SHAW LANE, CARLTON, S278 WORKS

Combined Stage 1 and Stage 2 Road Safety Audit

Client: Vistry Group

19/08/2026

PROBLEM 2.2.4

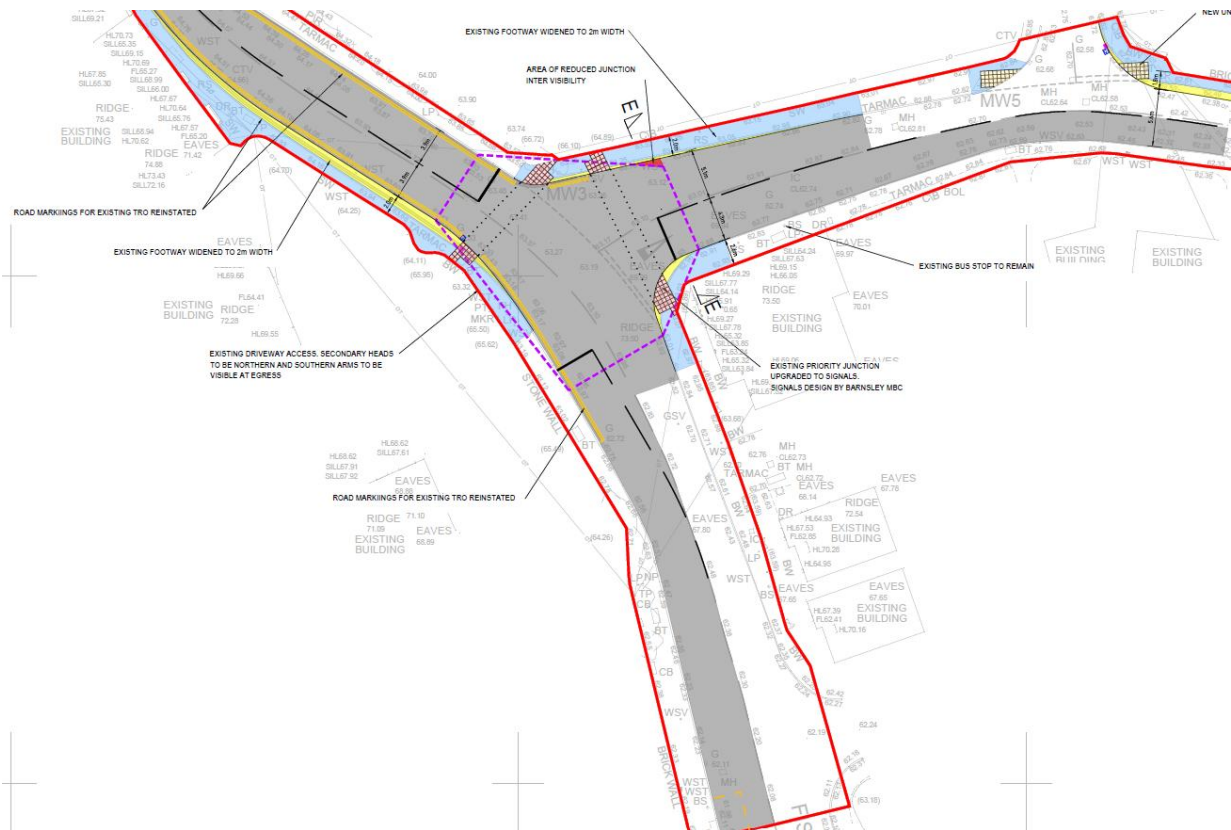
Location	Church Street / Fish Dam Lane / Shaw Lane traffic signals.
Summary	Potential for head-on conflicts.

Like-for-like double yellow lines will be reinstated at the junction following installation of the new traffic signals. Nevertheless, inconsiderate on street parking in Fish Dam Lane or Shaw Lane could cause conflicts, as drivers go into the opposing lane to make progress. Furthermore, vehicle detection and junction capacity may not operate as intended, with vehicles parked on-street.

It is recommended that at least 40m from stop line of 'no waiting at any time' is provided for both Fish Dam Lane and Shaw Lane.

PROBLEM 2.3.2

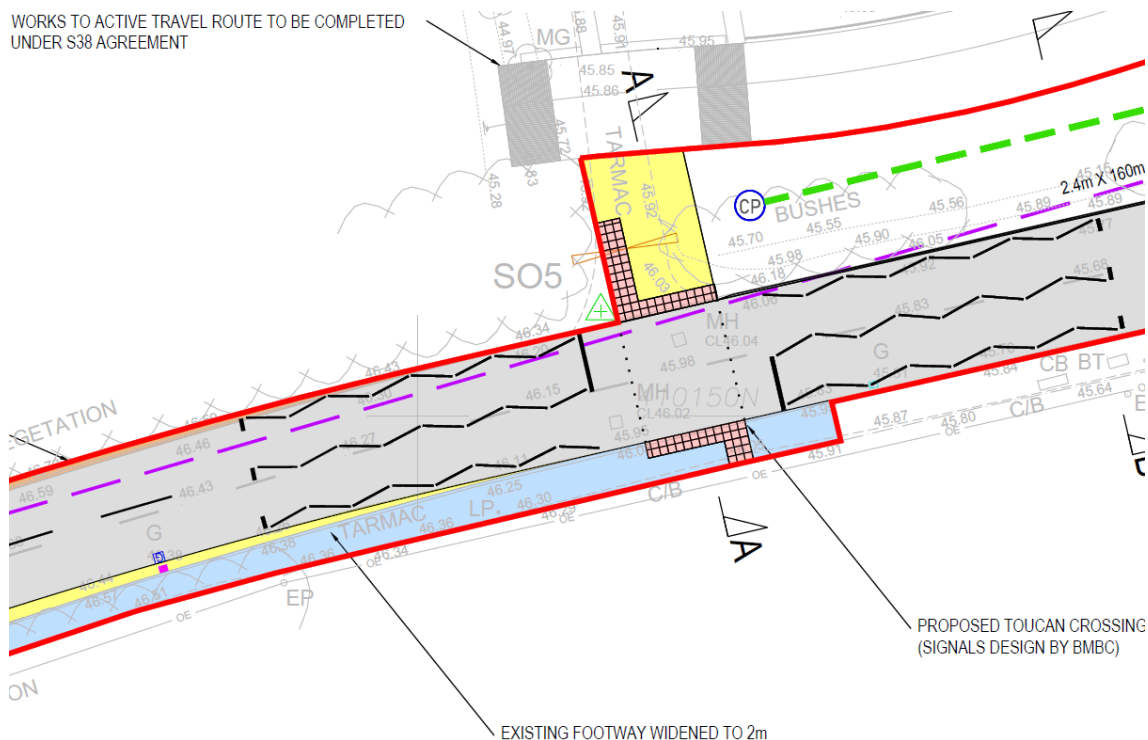
Location	Proposed Toucan crossing in Shaw Lane.
Summary	Potential for a vehicle / pedestrian (or vehicle / cyclist) collision.

There is insufficient footway width on the south side of the new Toucan crossing for shared use by pedestrians and cyclists. Consequently, it is possible that a pedestrian or cyclist will encroach the adjacent carriageway, potentially leading to a collision. In any case, there is no onward route for cyclists on the south side of Shaw Lane.

It is recommended that a Puffin crossing is installed and that the proposed crossing facility is for pedestrians only e.g. a sign could be erected CYCLISTS DISMOUNT OR REJOIN CARRIAGEWAY.

Appendix B: Location Plans

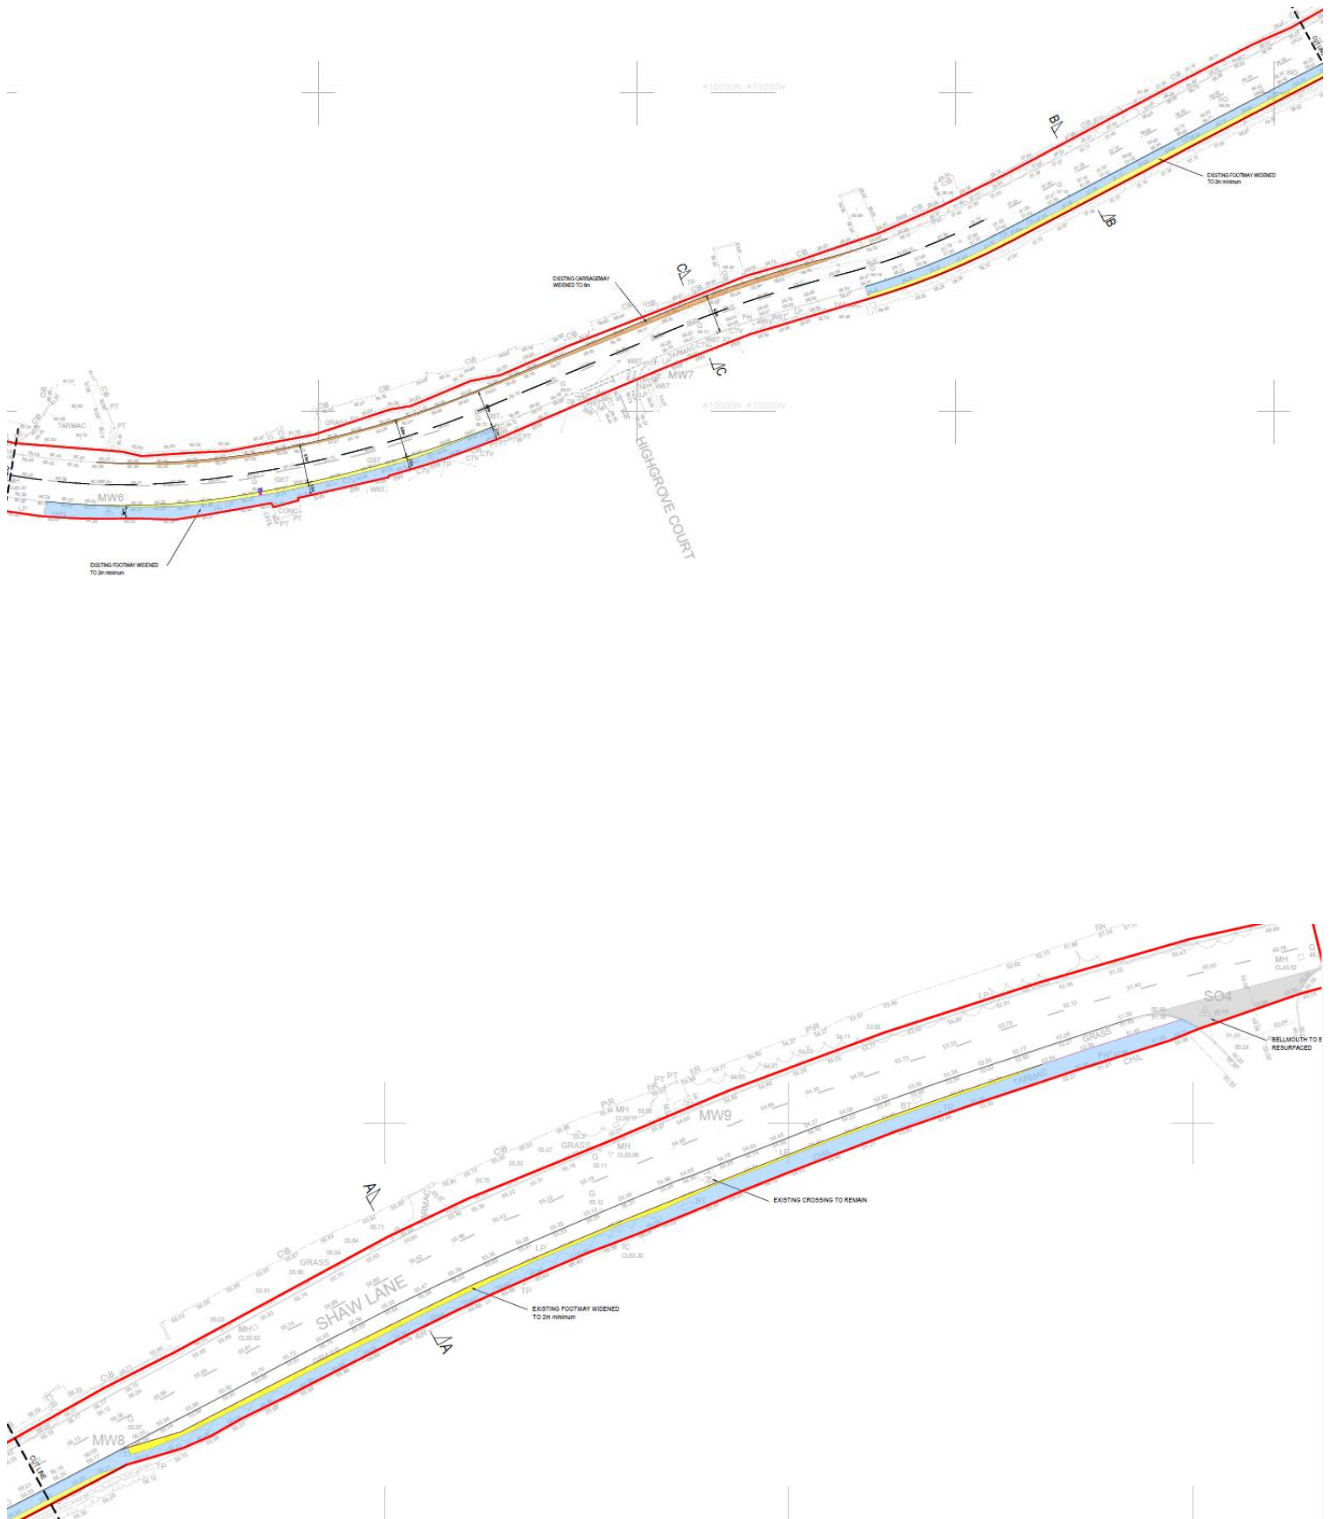
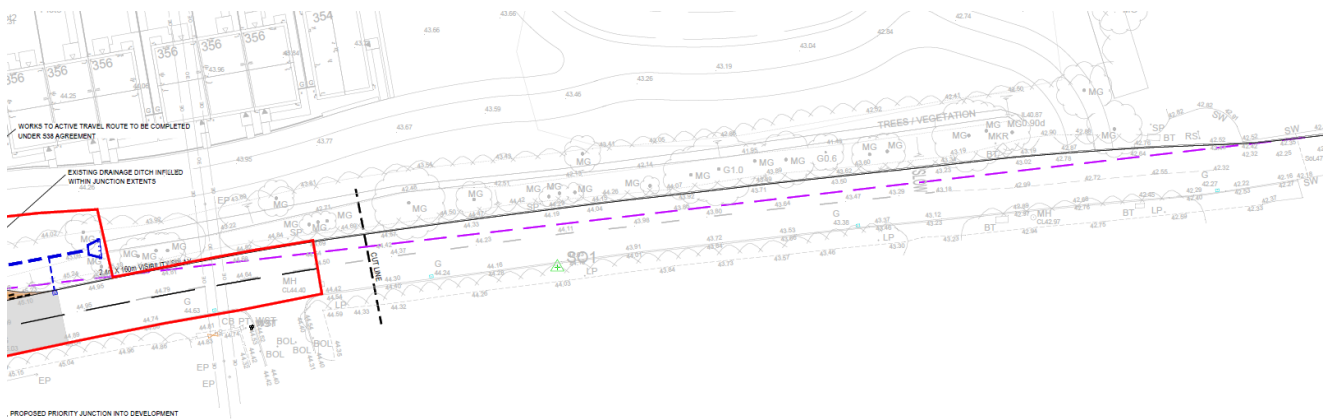
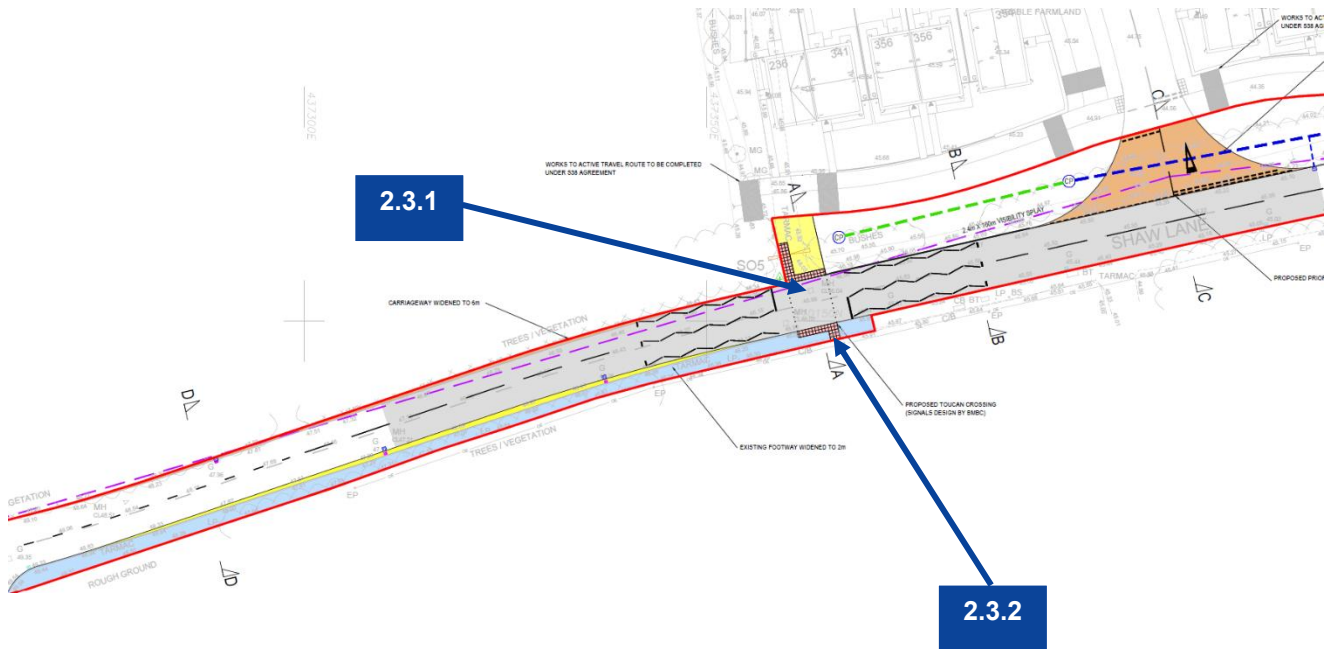
PROBLEM 2.1.1	
Location	Shaw Lane, redundant bus stops adjacent to: 1. Fish Dam Lane junction 2. Site access junction.
Summary	Possible hazards associated with a waiting bus at a bus stop near a junction.
There are two redundant pairs of bus stops in Shaw Lane: • westbound and eastbound bus stops near the proposed Fish Dam Lane traffic signals; and • westbound and eastbound bus stops adjacent to the proposed site access junction. If these bus stops are brought back into use, stopped buses could restrict visibility on the approach to traffic signals and / or become a hazard for turning traffic at site access junction.  	
RECOMMENDATION	
It is recommended that the redundant bus stop poles / flags are removed.

PROBLEM 2.1.2	
Location	1. Church Street / Fish Dam Lane / Shaw Lane traffic signals. 2. Shaw Lane Toucan crossing.
Summary	Potential for maintenance vehicle parking to restrict sight-lines at crossing points.
In the absence of suitable locations for maintenance vehicle parking, these vehicles could restrict sight-lines at crossing points or partially obstruct the carriageway, possibly leading to conflicts.	
RECOMMENDATION	
It is recommended that there are safe and convenient maintenance vehicle parking locations at both the traffic signal junction and the Toucan crossing.
